Strathfield Internal Development Assessment Panel Meeting

DA2019/036 - 18 Chiswick Street, Strathfield South

TO: Strathfield Internal Development Assessment Panel Meeting - 9 August 2019
REPORT: IDAP – Report No. 1
SUBJECT: DA2019/036 - 18 CHISWICK STREET, STRATHFIELD SOUTH
LOT 73 DP 11110
DA NO. DA2019/036

Proposal: Demolition of existing structures and construction of a new two (2) storey dwelling with basement level, relocation of vehicle entry, front boundary fence and outbuilding

Figure 3: Extract of the survey plan with the location of the easement identified in red.

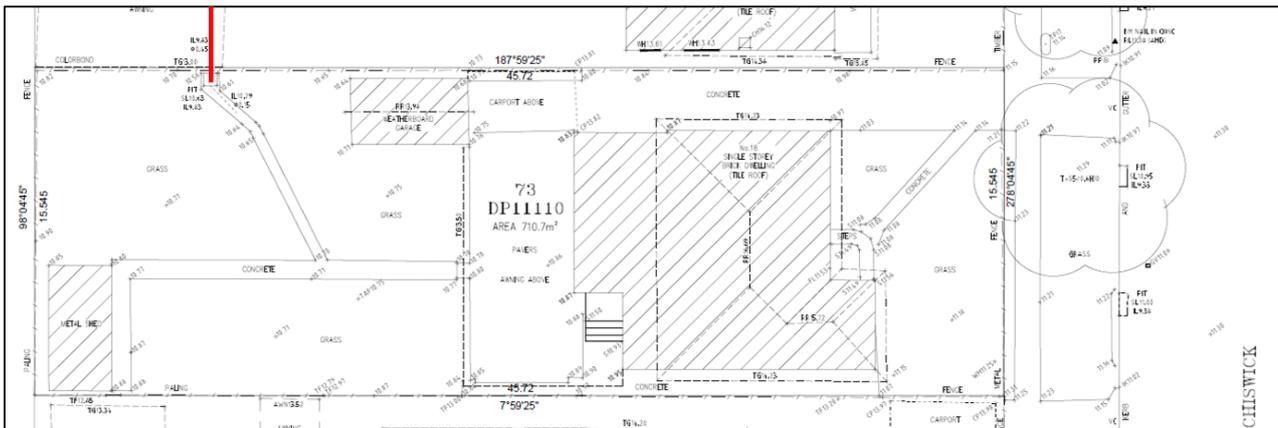
- Demonstration of genuine attempt to acquire connection to the downstream easement;
 - Re-location of the driveway is not supported due to the proximity to an existing stormwater pit and the existing driveway layback to be utilised;

An easement to drain water runs adjacent to the rear property boundary (Figure 3).

Figure 6: Elevation section of the proposed dwelling house (excludes the chimney).

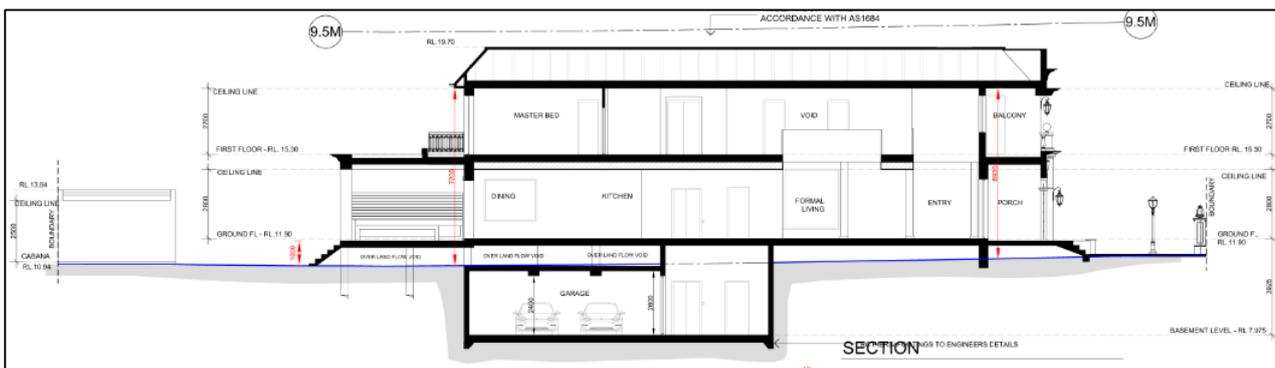
Comments: The proposed dwelling has a maximum building height of 8.9m which is below the 9.5m maximum permitted under Clause 4.3 of the SLEP 2012 (Figure 6). The overall building height is considered appropriate having regards to other more recently constructed two (2) storey dwellings in the surrounding streetscape.

In accordance with the above definition, chimneys are to be excluded in the calculation of building height, and therefore the height of the proposed chimney, located on the western elevation, has not been included in the assessment of the proposal’s compliance with the building height development standard.

Figure 11: Mid-winter shadow diagrams of the proposed dwelling.

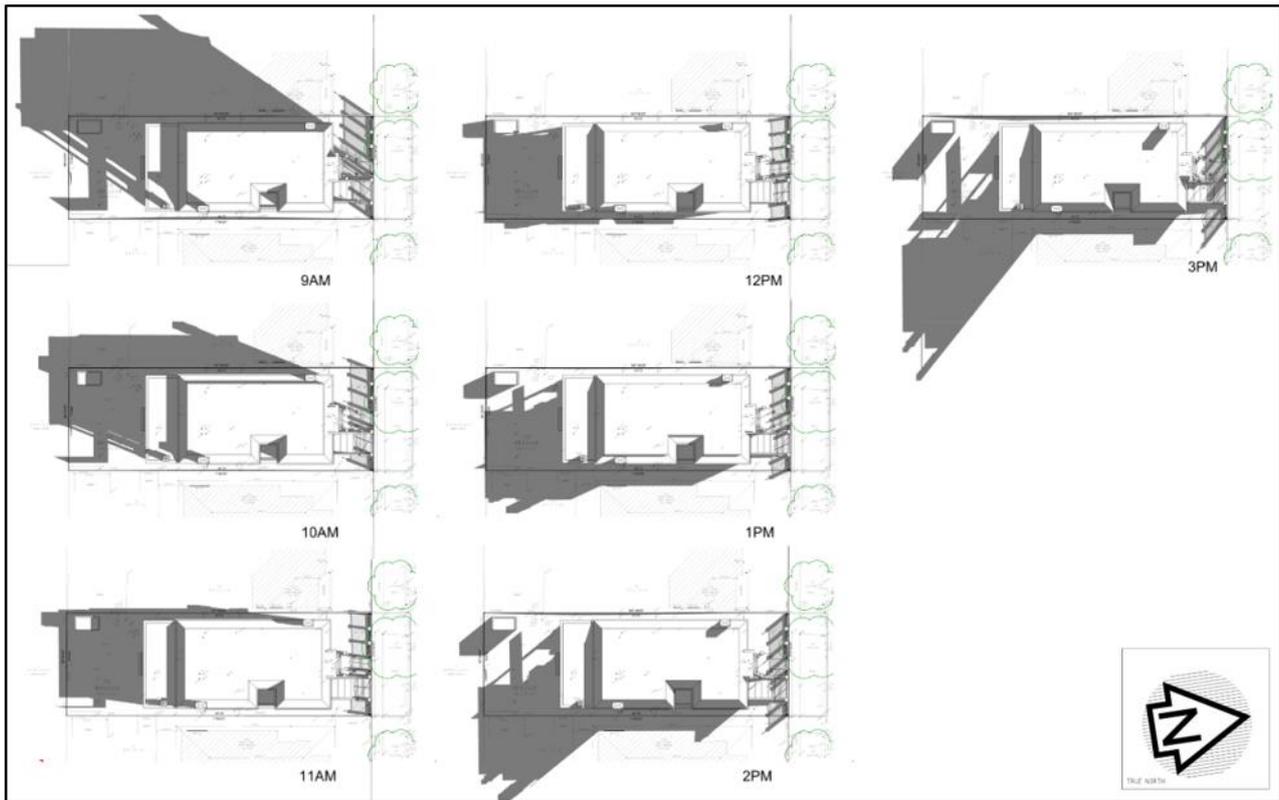
Comments: The subject site has a north-south orientation with the dwelling facing north, resulting in adjoining property to the east receiving full solar access from 9am to 1pm and the adjoining property to the east receiving full solar access from 12pm to 3pm (illustrated below). During the assessment process the adjoining eastern property owner raised concerns regarding solar access and consequently the two (2) storey roof of the alfresco area was reduced to a single storey. As the existing dwelling on the site to be demolished is single storey, a new two storey dwelling is inevitably going to result in the loss of solar access to the neighbouring properties, but the extent of this loss is considered reasonable in the context, and the neighbouring properties will still achieve the minimum amount of solar access required by the development controls.
